RE: Spring Farm Parkway Stage 2

Thank you for the opportunity to comment on Stage 2 of the Spring Farm Parkway project.

Figure 2: The shared user path (SUP) along the west side of Liz Kernohan Drive, Spring Farm. (Source: Google Maps)

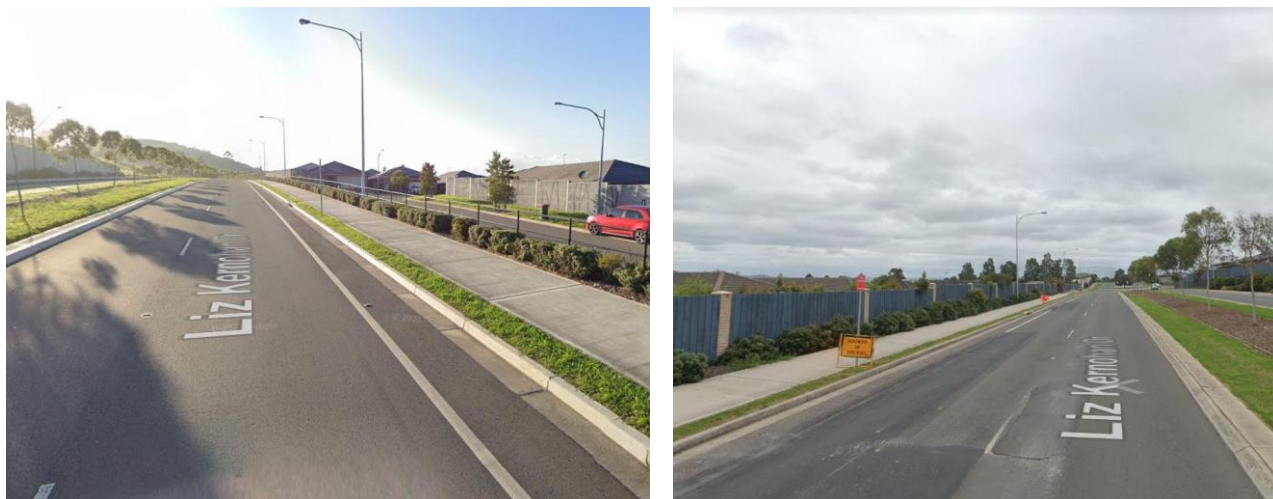
The project team confirmed that the twin SUPs will be set back from the kerb by a 2m verge to enhance the sense of safety and allow space for tree planting. It is essential that this ambition is not lost during the delivery of the new road. Bicycle NSW notes that the 2.4m SUP along Liz Kernohan Drive at the northern end of Spring Farm Parkway is separated from the kerb by an inadequate strip of grass less than a metre wide (Figure 2). In addition to the lack of separation from fast moving traffic, this verge does not support trees to create visual amenity and protect people walking and cycling from the intense sun. Residents will not choose active travel if it is not safe, attractive and comfortable.
